APPLICATION FOR PERMIT TO DRILL						1. WELL NAME and NUMBER GMBU 3-2-9-18H					
2. TYPE OF WORK DRILL NEW WELL <input checked="" type="checkbox"/> REENTER P&A WELL <input type="checkbox"/> DEEPEN WELL <input type="checkbox"/>						3. FIELD OR WILDCAT EIGHT MILE FLAT

Newfield Production Company
GMB 3-2-9-18H
NE/NW Section 2, T9S, R18E
Uintah County, UT

Drilling Program

Casing Schematic

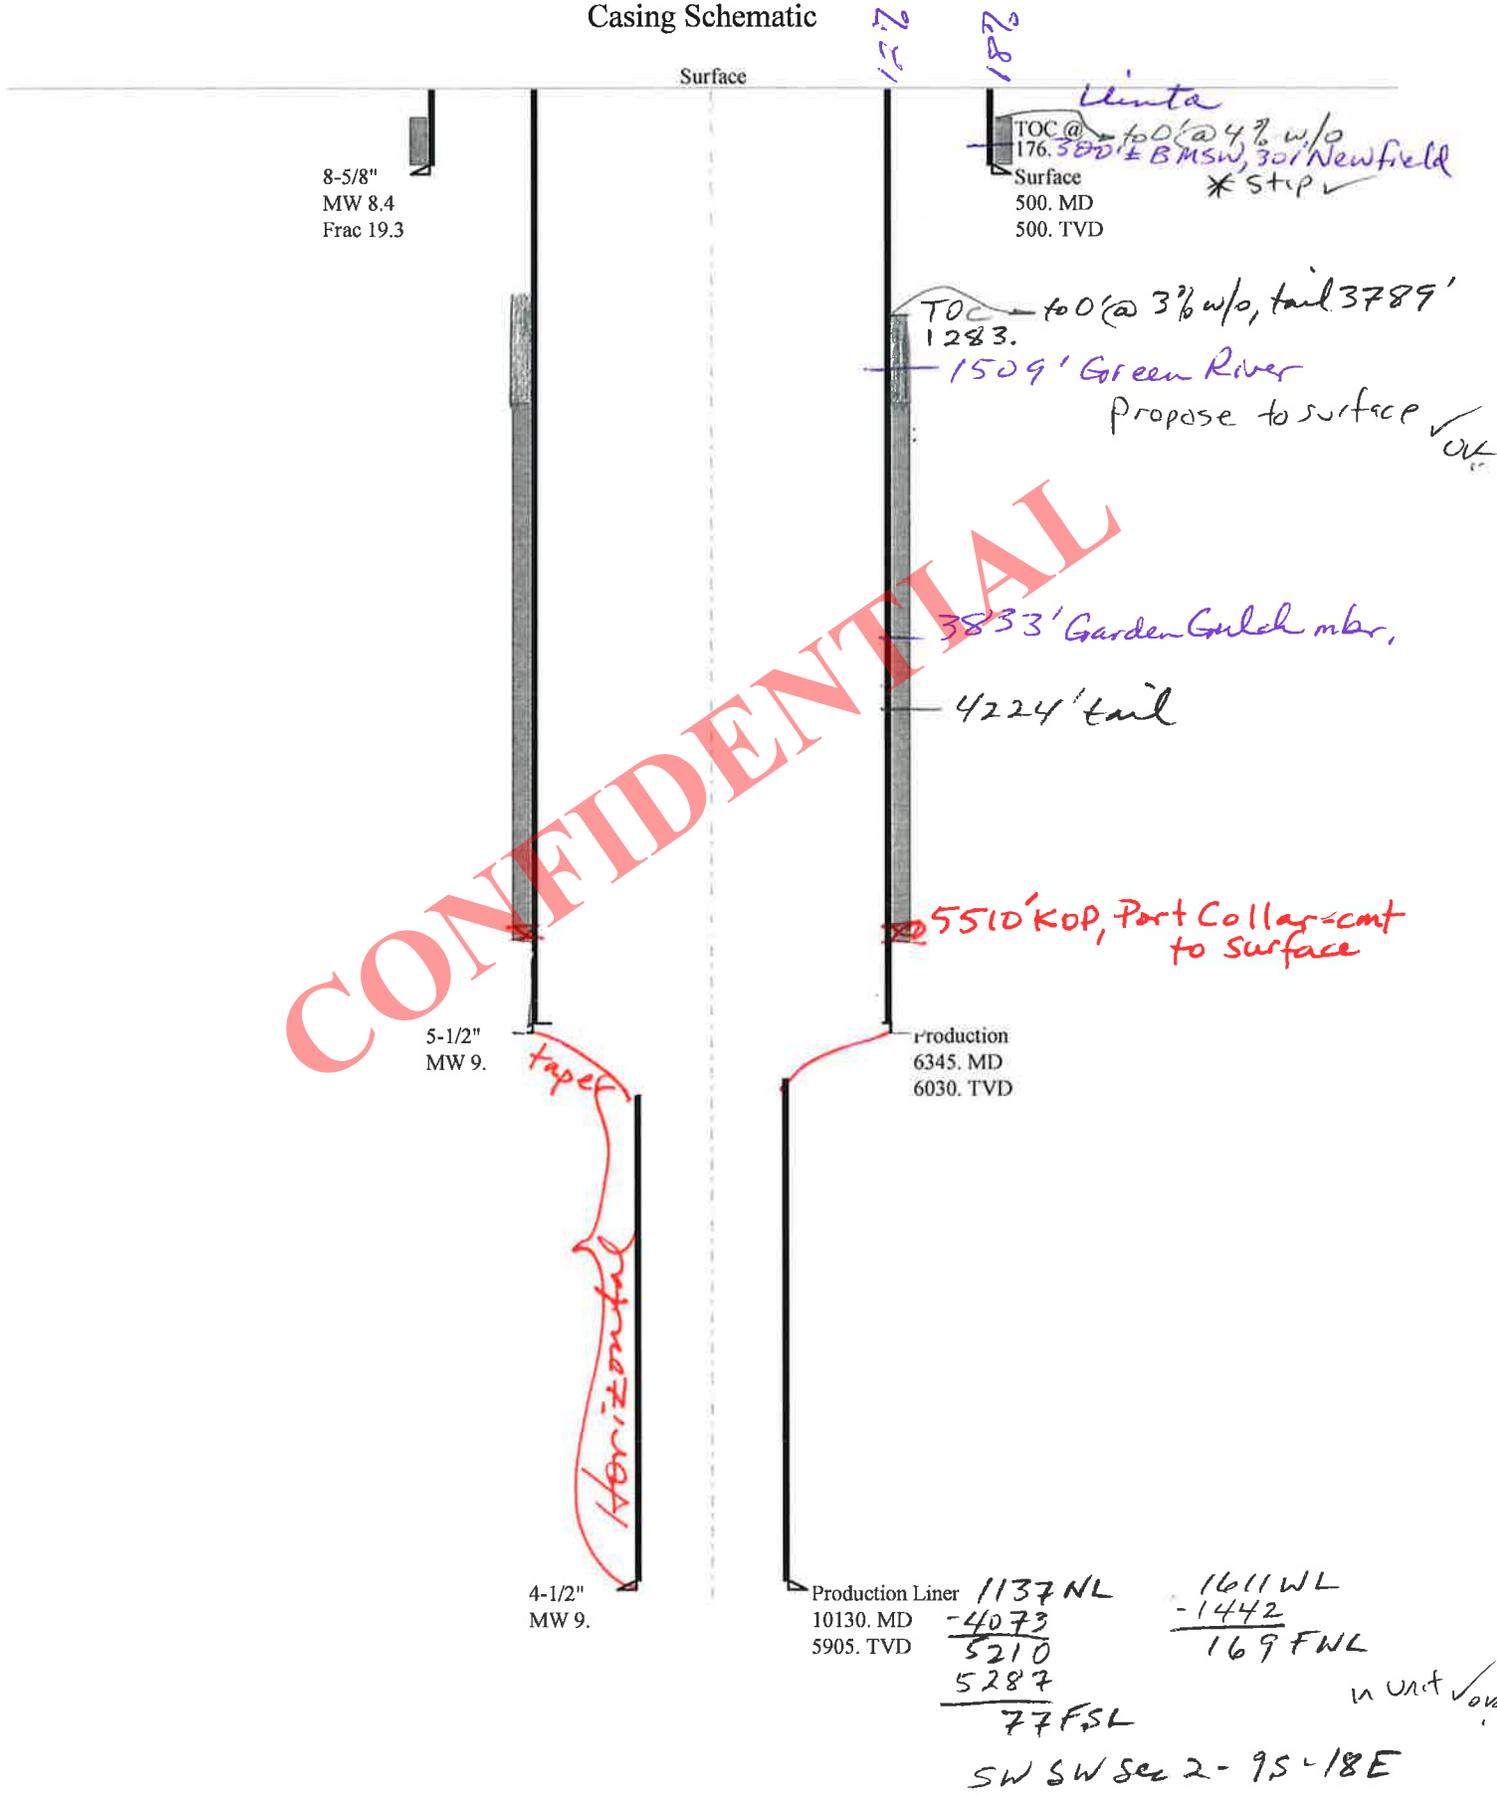
Cement volume for the 5 1/2 production string shall be determined from actual hole diameter in order to place cement from the pipe setting depth back to surface as indicated in the submitted drilling plan.
